CORRECTION

Cite this: Analyst, 2017, 142, 2846

Correction: A smart multi-pipette for hand-held operation of microfluidic devices

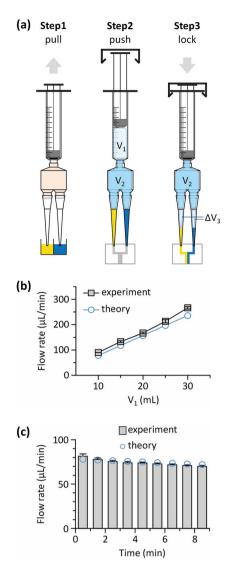
To reflect this change, amendments are required to Fig. 1 and the text.

- Fig. 1b and c are affected by the correction needed to the theoretical estimation for the generated pressure by the smart pipette, and the overall corrected version of Fig. 1 is as follows:
 - The first sentence on p. 5755 should be amended as follows:
- 'If $V_2 \gg (\Delta V_3)_t$ and $V_1 \gg (\Delta V_3)_t$, the pressure change becomes negligible and thus the smart multi-pipette maintains a constant pressure during device operation.'
 - The fourth sentence of the third paragraph on p. 5755 should be amended as follows:
 - 'We note that the experimental value is higher than the theoretical expectation of 7.8%.'
 - The changes do not affect any of the conclusions of the article.
 - The Royal Society of Chemistry apologises for these errors and any consequent inconvenience to authors and readers.
